ADMIRALTY SIGNAL AND RADAR ESTABLISHMENT

VALVE ELECTRONIC

CV2374
CV2375

Specification AD/CV2374 and CV2375 Issue No.1 Dated 23rd September, 1955 To be read in conjunction with K1001	<u>SECURITY</u>	
	<u>Specification</u> Unclassified	<u>Valve</u> Unclassified

CV2374
CV2375

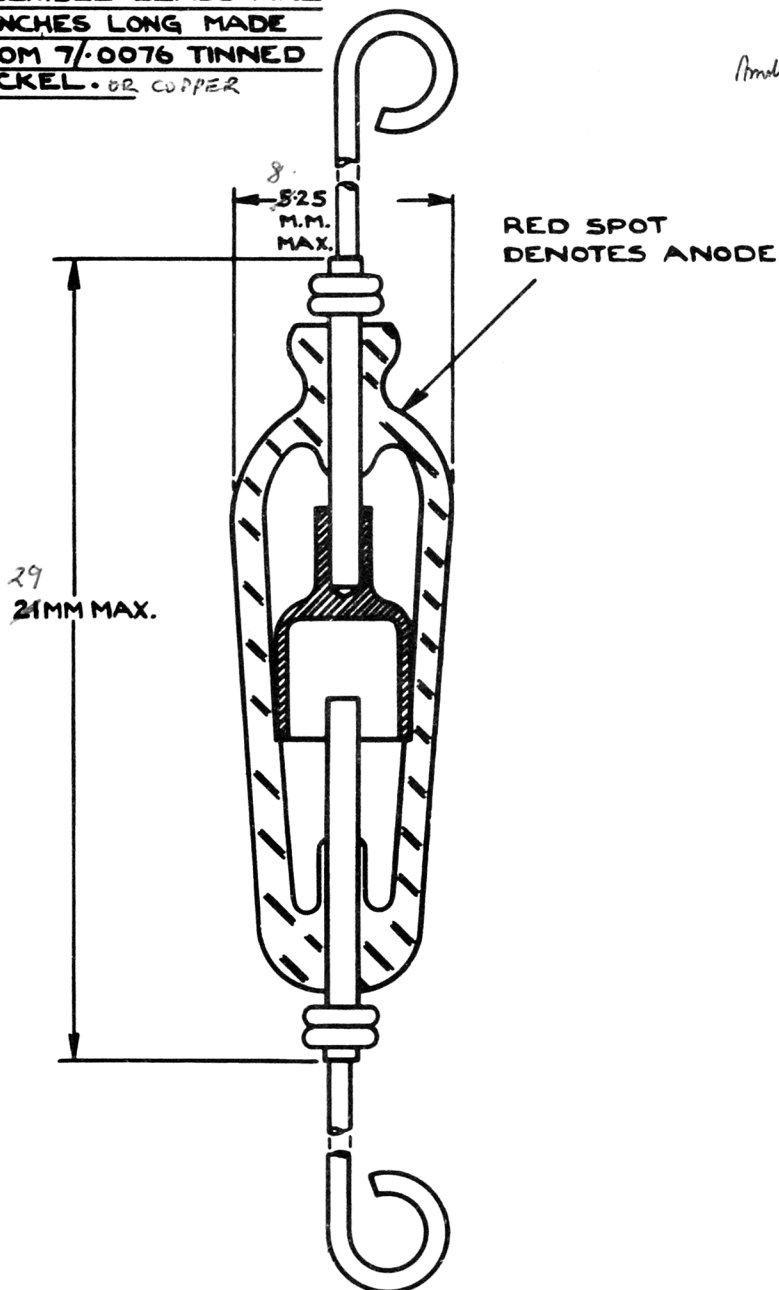
Page 3 Drawing Dimensions. Amend length:-
from 21 mm max. to 29 mm max.

Amend diameter:-
from 5.25 mm max. to 8.25 mm max.

Page 3. Note on drawing, beginning "Flexible Leads."

Add the words "or copper" after "nickel".
